REVISION TRANSMITTAL

This sheet transmits Revision 1 to SB700-23-03 which:

COMMUNICATIONS - GOGO AVANCE L5/GARMIN INTERFACE

SB700-23-03
Page 1 of 9

Figure 1. GOGO Avance L5/Garmin Interface Electrical Wiring Modification (Sheet 1)

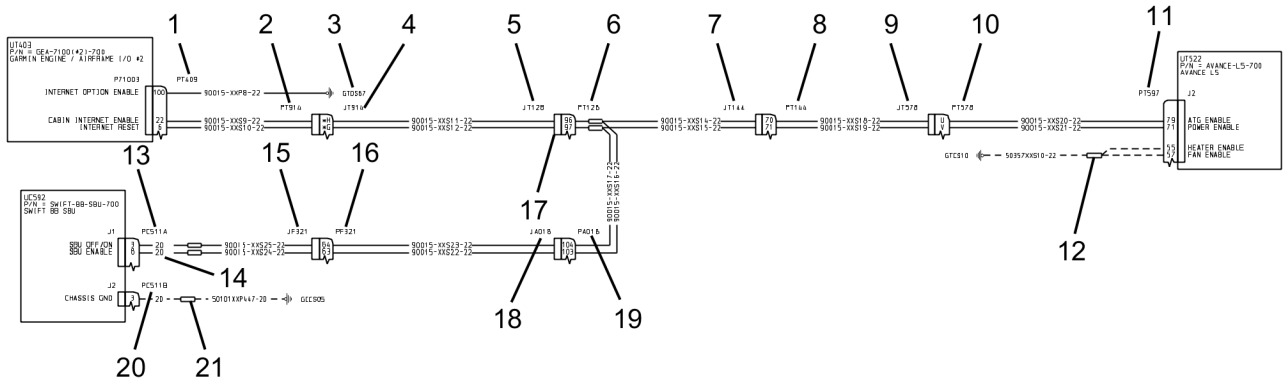
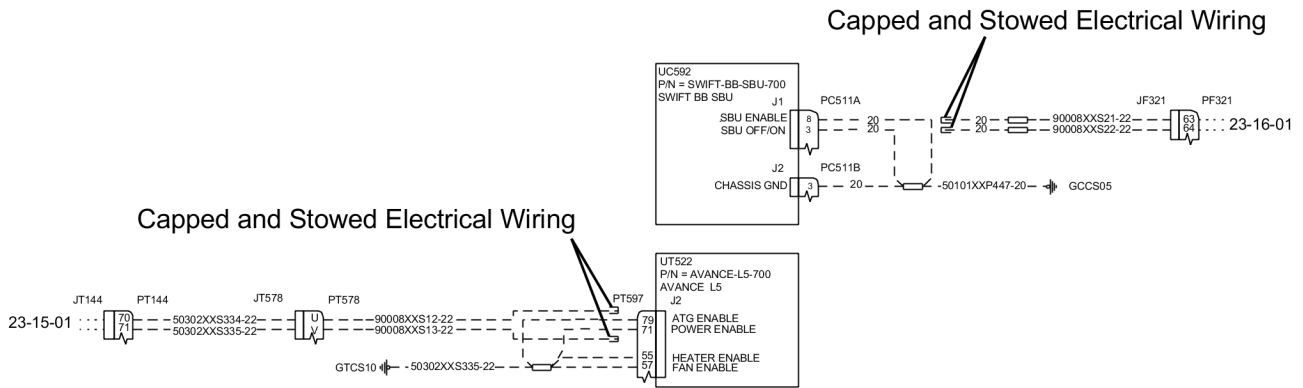
This service document provides parts and instructions to add the capability to control the GOGO Avance L5 internet from the flight deck.

Before Modification
Aircraft -0001 thru -0030

After Modification
Aircraft -0001 thru -0030

Figure 1. GOGO Avance L5/Garmin Interface Electrical Wiring Modification (Sheet 2)

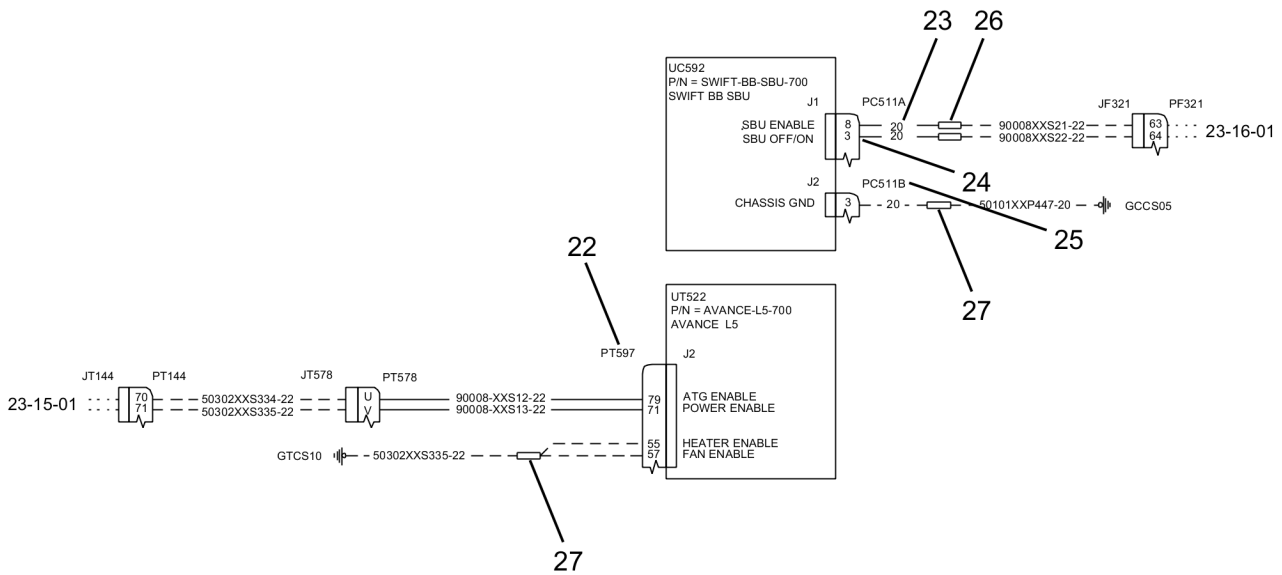
Before Modification
 Aircraft -0031 and -0032

After Modification
 Aircraft -0031 thru -0032
